UNITED STATES PATENT AND TRADEMARK OFFICE

Office Action Summary

10/823,357

DETAILED ACTION

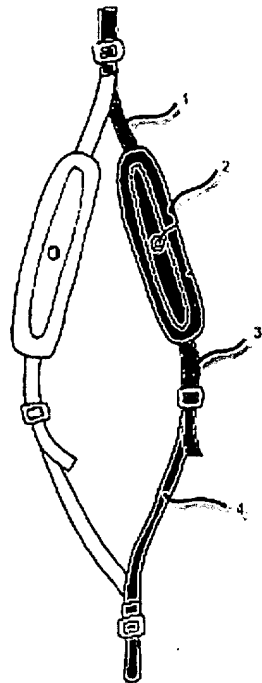
Regarding claims 7 and 8, the first strap of Kakouras includes the four claimed segments as set forth in the figure presented below. The first segment (1, below) includes the first buckle. The second segment (2, below) includes a pad (15). The fourth segment (4, below) is adjustably coupled to a third segment (3, below) and includes the second buckle.
